## ANN ARBOR HISTORIC DISTRICT COMMISSION

### Staff Report

**ADDRESS:** 1310 Hill Street, Application Number HDC16-012

**APPLICATION:** The applicant seeks HDC approval to replace the egress door on the southeast corner of the house with a basement egress window beneath a replica of the historic basement window. The window has a well that is 48"x48", built of the same retaining wall blocks proposed on previous applications, and featuring a single step and a ladder.

1310 HILW STREET - HDX Application  
Egress Well plan  
1/2" = 1'-0"

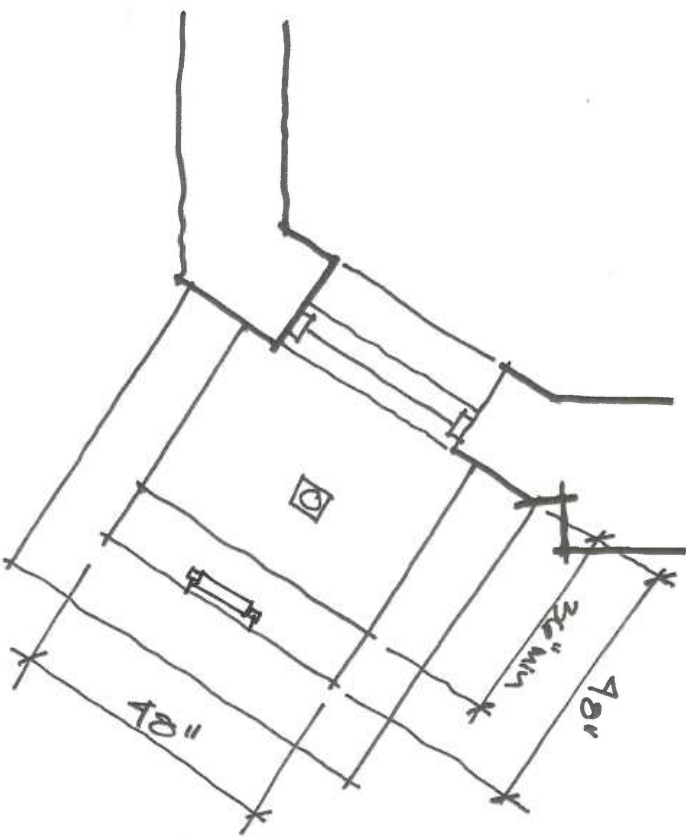
1. The proposed egress window is a push-out casement style of aluminum-clad wood. The 48" x 48" well with block retaining walls has one 12" deep step and a ladder to aid in exiting the 60" deep well. The egress window would be mounted below a replica of the historic three-light basement window that was removed. Staff has requested an additional drawing of the elevation view that would show the replica window, egress window, and reinstalled historic cut stone above grade.
2. Configuring the egress window below the basement window results in a deeper well, but better retains the historic appearance of the basement window above grade.
3. Staff feels that the proposed egress window's location, size, and design are appropriate.

I move that the Commission issue a certificate of appropriateness for the application at 1310 Hill Street, a contributing property in the Washtenaw/Hill Historic District, to add a basement egress window on the condition that the proposed barrier is secured along the driveway near the street prior to the issuance of building permits. The work is compatible in exterior design, arrangement, texture, material and relationship to the rest of the building and the surrounding area and meets the *Ann Arbor Historic District Design Guidelines*, especially those for windows, and the *Secretary of the Interior's Standards for Rehabilitation* and *Guidelines for Rehabilitating Historic Buildings*, in particular standards 2, 9 and 10 and the guidelines for windows.
